## CALICE Oversight Committee - Questions and Answers

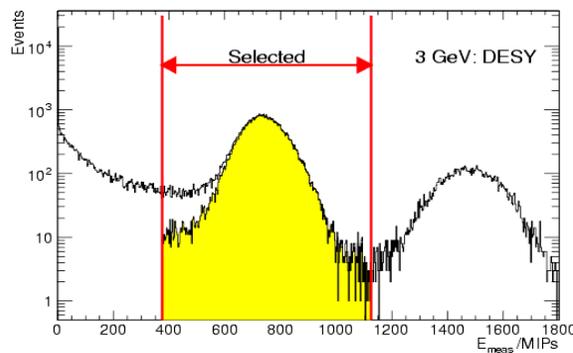
(c) Any plots to illustrate the difference discussed in (b)?

(d) What are double showers? What is their likely origin?

The open histogram is data and the yellow histogram is MC. In general the low energy halo, and the extent to which it leaks into the signal region, is the greater worry. The cut to separate two particles is not too bad, though it gets less clean at lower energies of course.

At DESY, this was due to pairs of beam electrons in the same bucket. In the plot above you can see that the energies of the two peaks are in the ratio 1:2. There is a different double shower problem at CERN, which appears to be associated with bremsstrahlung far upstream, giving a lower energy beam particle accompanied by a photon, so that the total energy seen is still effectively the beam energy.
